HISTORIC RESOURCES DESIGN REVIEW 1037 Harrison Street, Santa Clara, CA 95050 September 13, 2021

Lorie Garcia (Beyond Buildings) was retained by Tom Chan, to conduct a Historic Resources Design Review of his proposed rehabilitation project at 1037 Harrison Street, Santa Clara, California. Ms. Garcia was asked to review the exterior elevations, plans and site plan of the project to determine if the proposed project is in compliance with the *Secretary of the Interior's Standards for Rehabilitation* (Standards). The Standards are understood to be the prevailing set of guidelines for the review of historic buildings and are used by many communities during the environmental review process to determine the potential impact of a project on an identified historic resource.

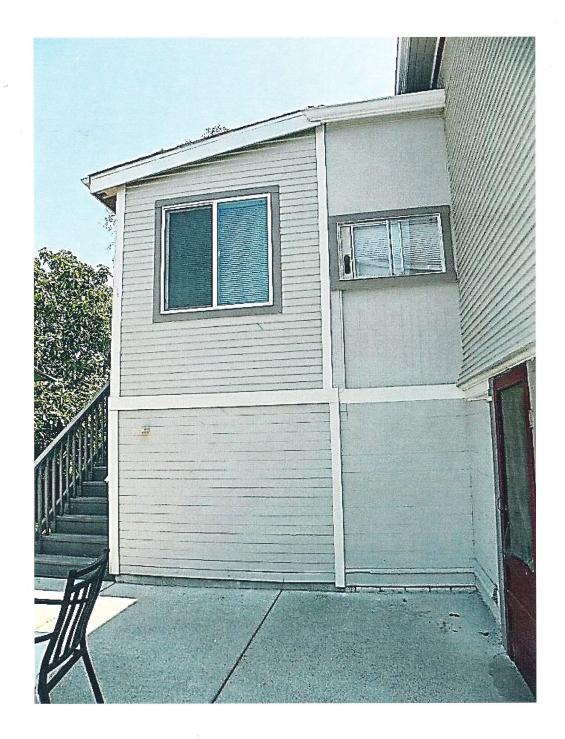
Item 3 proposes removing the exterior rear stairs and landing that provide access to an entry door opening into the main/living level of the rear projection. These are not original (rebuilt in 2016). Also, the location of the exterior stairs appears to have at some time been moved from the original site of the rear entry stairs. Removing the stairs and landing will not destroy historic materials, features, and spatial relationships that characterize the property. **See Appendix A. Photo 1.**

Item 5. As proposed, the placement of a new 2'8" x 4' picture window and new compatible siding into the previous door opening utilizes the space once occupied by the non-original rear door that provided access to the main/living level of the two-story rear projection and will not destroy historic materials or features that characterize the property. **See Appendix A. Photo 1.**

Preliminary plans, dated August 8, 2021 Existing and Proposed elevations

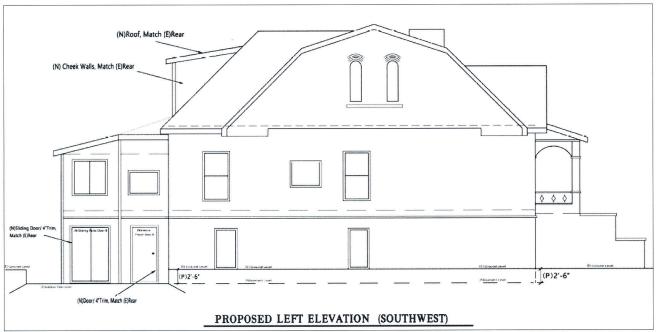
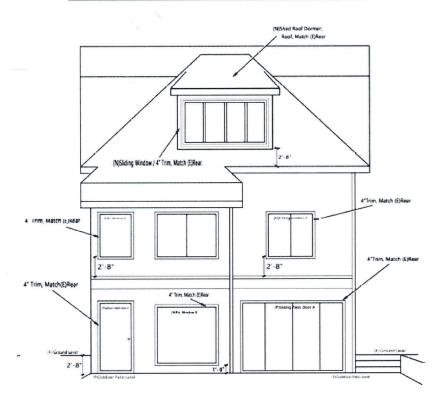
Items 3 through 6 involve alteration of the rear or secondary façade and related new construction. As shown on the plans dated 08/08/21, E. Rear Elevation (Northwest) and Proposed Rear Elevation (Northwest), E. Left Elevation (Southwest and Proposed Left Elevation (Southwest), the alterations proposed for the rear façade of the main house include the replacement of a non-original wood entry door with sliding patio doors at the basement level and the construction of a window into the rear of the main/living level, which is currently an unbroken wall. Those proposed for the west and rear elevations of the hipped roof two-story projection, include the removal of this projection's stairs landing, and entry door into the main/living level and insertion of a picture window into part of the space once occupied by the entry door, replacement of a non-original wood entry door with a glass French door into part of the basement level and construction of a large picture window adjacent to the door in what is currently an unbroken wall, along with construction of two new entry doors in the projection's west side elevation's basement level. Also proposed is the creation of a new shed-roofed dormer with a sliding window in the rear face of the original hipped roof. See Appendix B.

However, a new 4' x 4' sliding window is proposed to be constructed in the rear of the main/living level of the main house, which currently is unbroken by any openings. The removal of original narrow bevel siding on the main/living level to insert the window will destroy historic material. While currently the non-original windows on the two-story rear projection are sliding windows, this new 4' x 4' sliding window in the main/living level of the body of the house will not be compatible with the original, historic, vertically orientated, wood-framed double-hung window style that exists on this level of the house's front and side elevations. **See Appendix A, Photo 3.**

Item 6. The shed roofed dormer proposed to be constructed in the rear face of the main house's original hipped roof in order to allow creation of a "Loft" or livable space in the attic, will be a compatible feature, as a shed -roofed dormer is a typical dormer for this architectural style. It will have horizontal siding that is compatible with the original horizontal siding of the house however, the sliding window is not a compatible window style as these dormers typically had a row of individual windows. **See Appendix A, Photo 4.**
